Product Support Bulletin 2010-001

Maintenance of Way ~ Work Equipment Bulletin

SUBJECT: Carbide-lined Spike Trays and Tray Heads for 5/8” Spikes

Figure 1
LH and RH Workheads

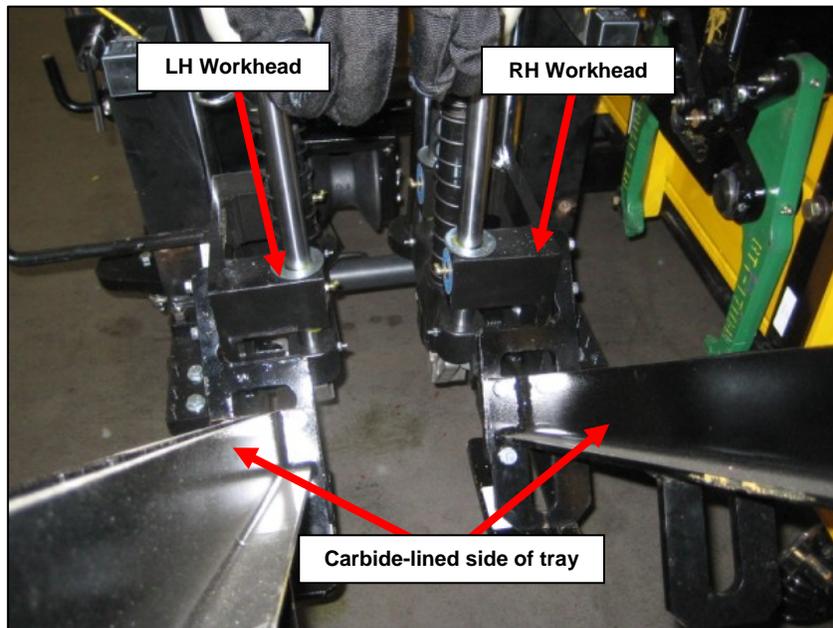
SUMMARY: Carbide-lined Spike Trays and Tray Heads are now available to add to the existing machines listed above or as an option on new machines. See Figure 1 on Page 2.

Carbide-lined Trays and Tray Heads have carbide tiles installed on various wear surfaces and are interchangeable with the standard Trays and Tray Heads. See Figure 2 on Page 3. The Spike Trays have carbide tiles attached to one side of the tray. The tray should be installed so the carbide-tiled side of the tray is toward the rail. See Figure 1 on this page. Please see the chart on this page to determine the correct part numbers to order. **Note: These Carbide-lined Trays and Tray Heads are not designed to be used on machines equipped to drive 9/16" spikes, oversized ("fat") spikes, lag screws or Lewis Evergrip™ spikes.**

5/8" Spike Trays and Tray Heads		
Description	Standard	Carbide-lined
RH Tray	82090064	82090200
LH Tray	82090064	82090202
RH Tray Head	82090093	82090210
LH Tray Head	82090094	82090215
